## Adaptec Technical Memorandum

NCITS T10/97-198r0

**Subject:** Status / Message Simplification for SCSI LFP

Figure 35 - Valid service request sequences for target role agents

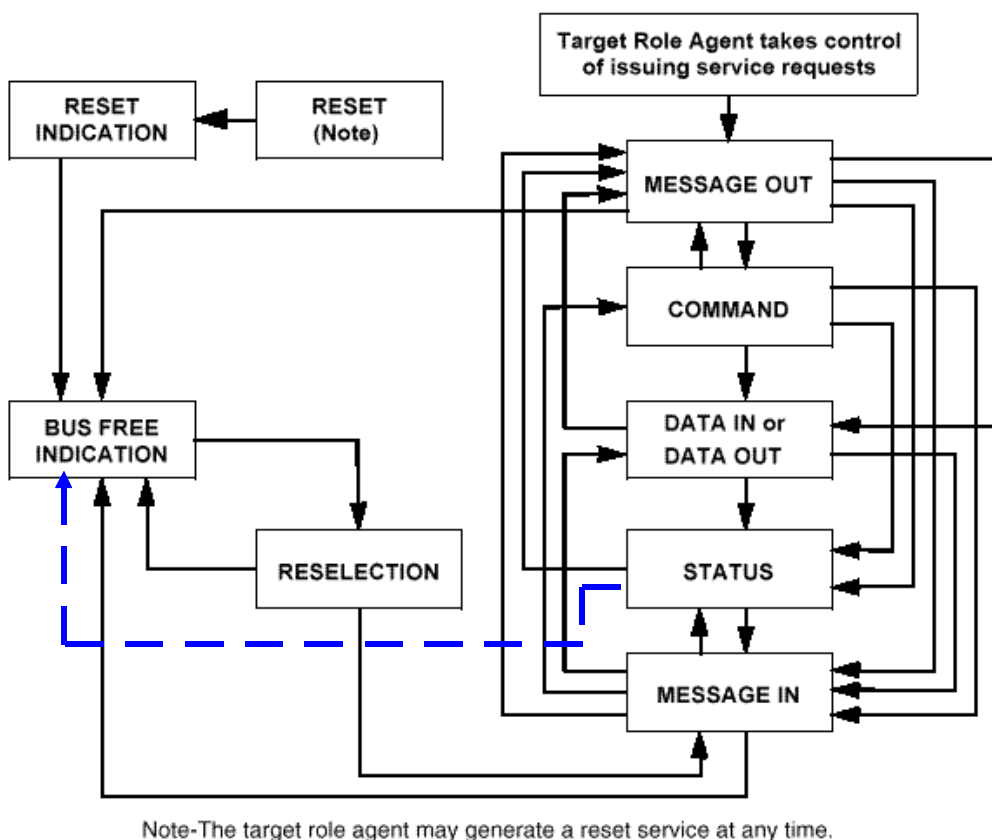
Figure 35 shows all the valid service request sequences allowed by the SCSI-3 Interlocked Protocol Standard for a target role agent. Any attempt to request a sequence not defined in figure 35 shall result in a protocol error. When a target role agent detects a protocol error it shall request a bus free service.
